**WHEELING PLAN COMMISSION
THURSDAY, JANUARY 24, 2019 6:30 P.M.**

REQUEST FOR PLAN COMMISSION ACTION
STAFF PROJECT REVIEW

RE: **Docket No. SCBA 18-52**
Destaco
1444 S. Wolf Road
Appearance Approval of Freestanding Signs

RE: **Wolf Road Industrial – Panattoni Development**
1020, 1022, 1026, 1027, and 1030 Carol Avenue; 10321 Dean
Avenue; 37 Kerry Lane; and 1032 S. Wolf Road
Docket No. 2019-1
Rezoning from the R-1A Single-Family Residential and I-1
Light Industrial to I-2 Limited Industrial District;

EAST ELEVATION
SCALE: 1/16" = 1'-0"

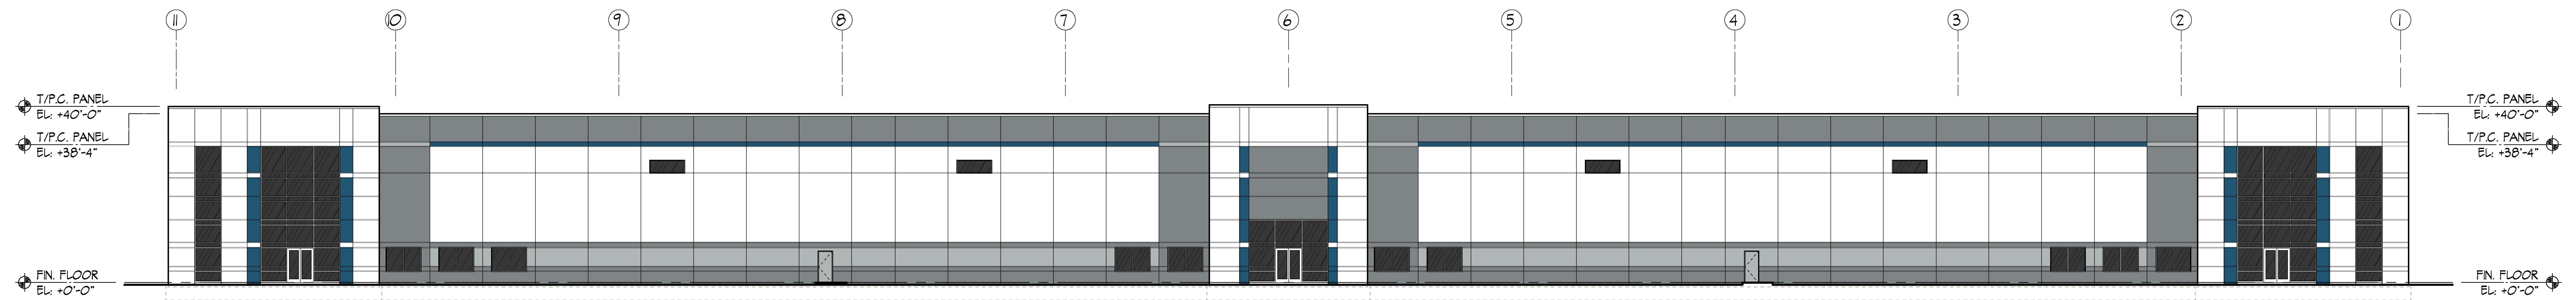
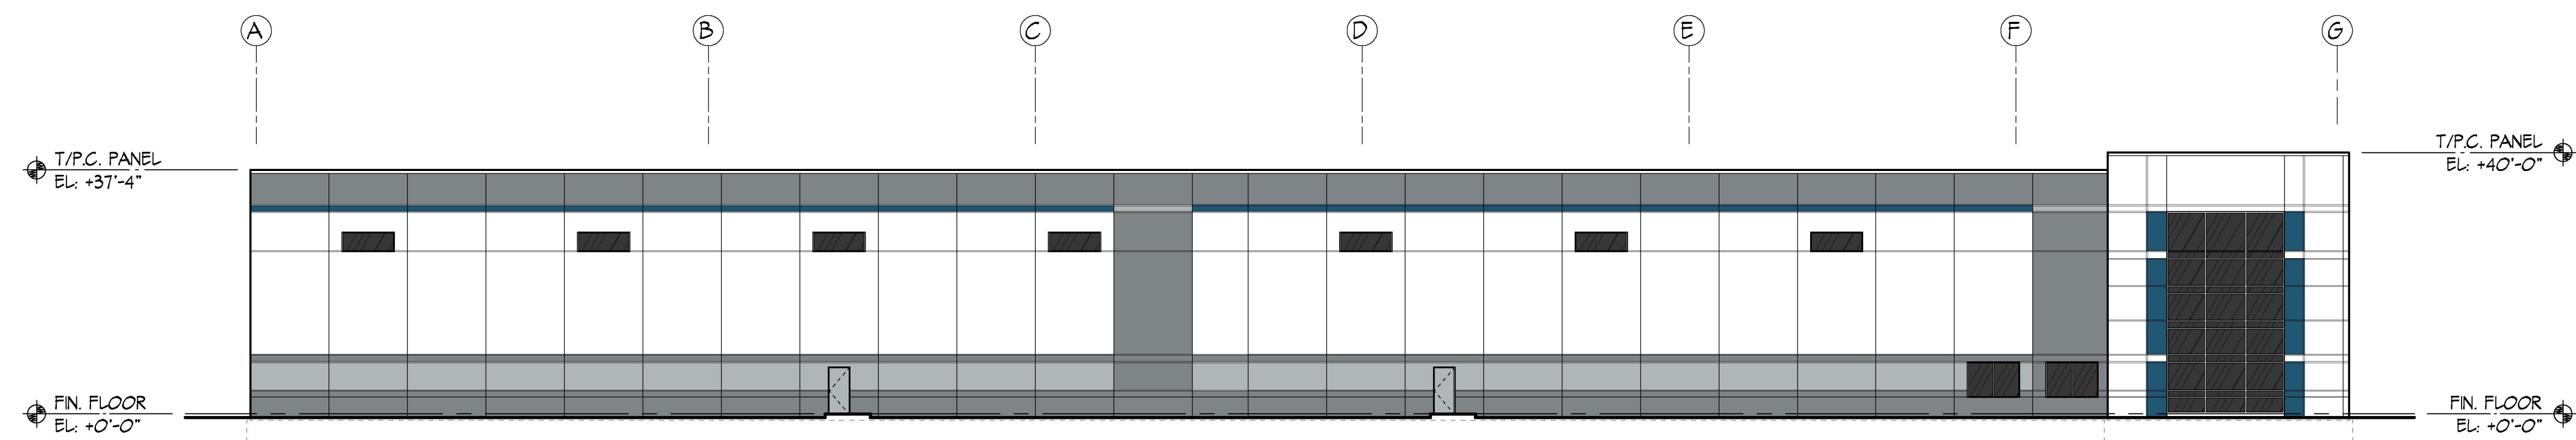
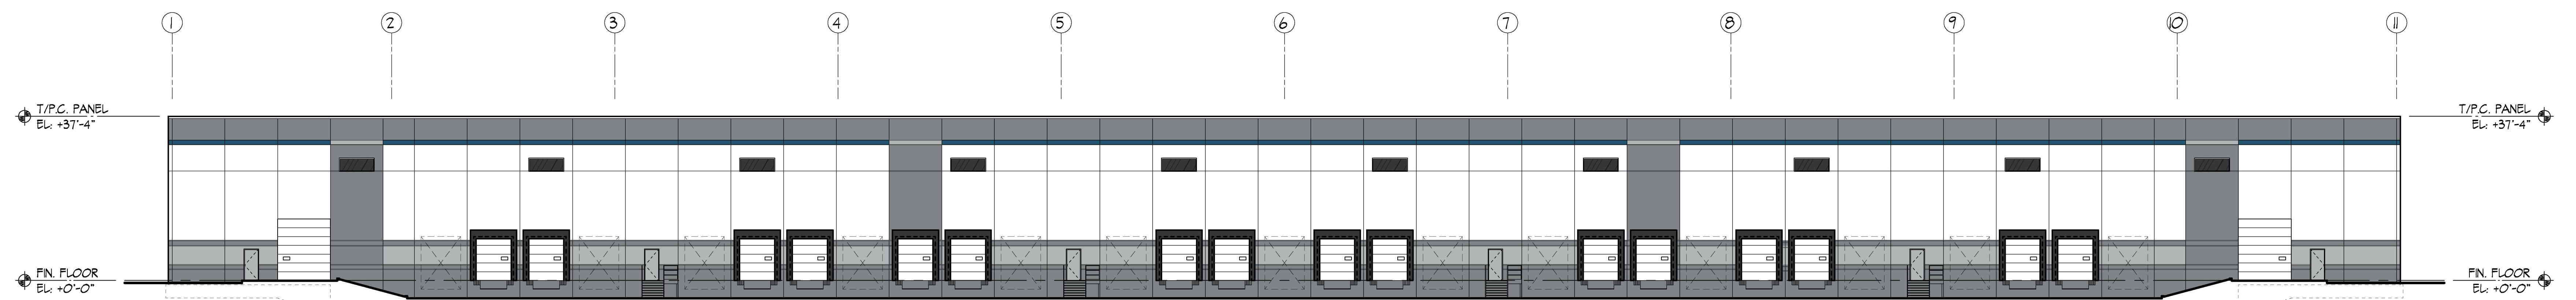
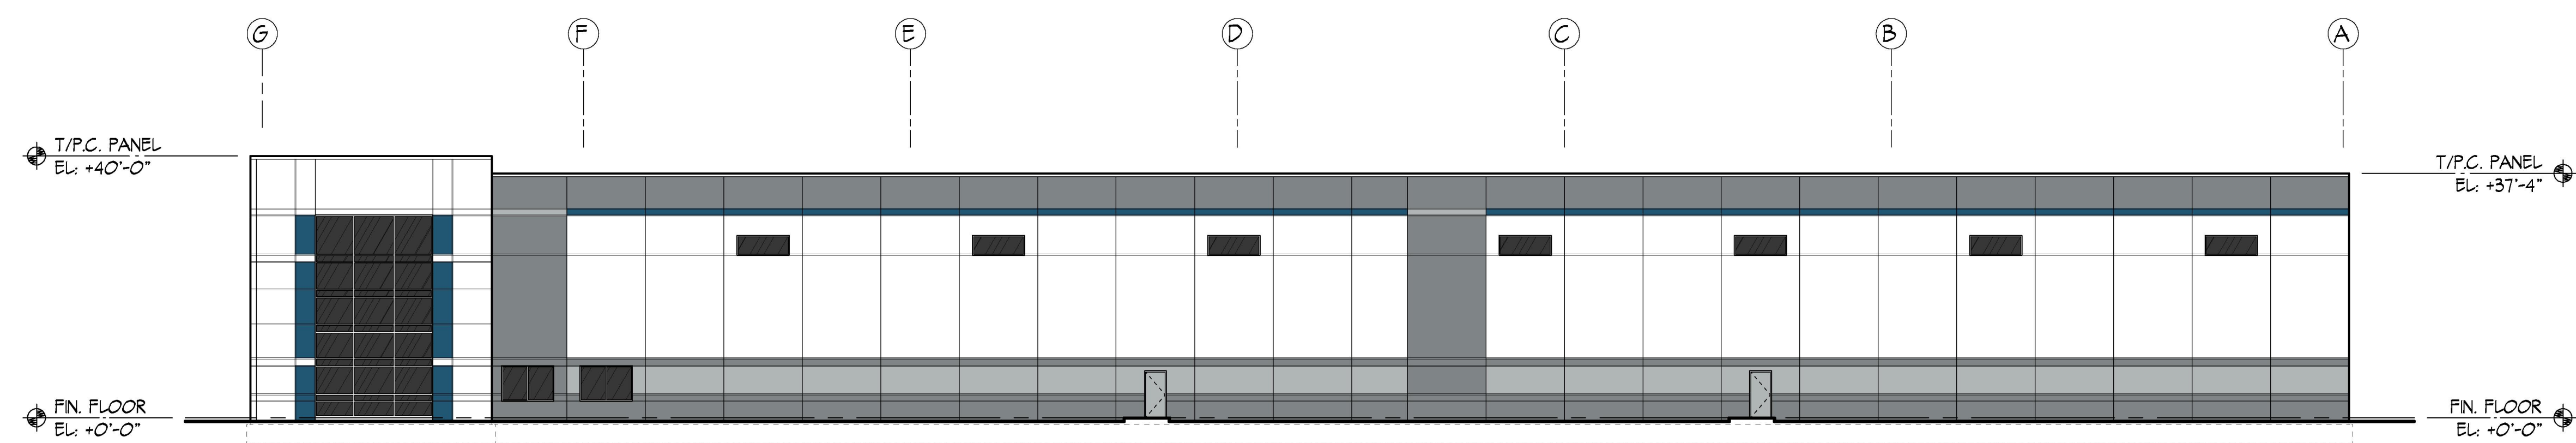
Elevation plans: A building elevation plan is provided illustrating the design of all four building elevations. The front (east) elevation includes emphasized tower elements to draw attention to the three main points of entry for the individual occupant spaces. The north and south entry features wrap around the sides of the building providing further visual interest at the northeast and southeast corners of the building. The entirety of the building will be constructed of precast concrete panels, with a white and grey color tone. Blue color accents are provided on all four sides to offer additional color interest to the building. Windows are included on all four building sides, with a majority of windows provided at the three entries, and on the north and south elevations, which provides an attractive break from the standard precast concrete walls.
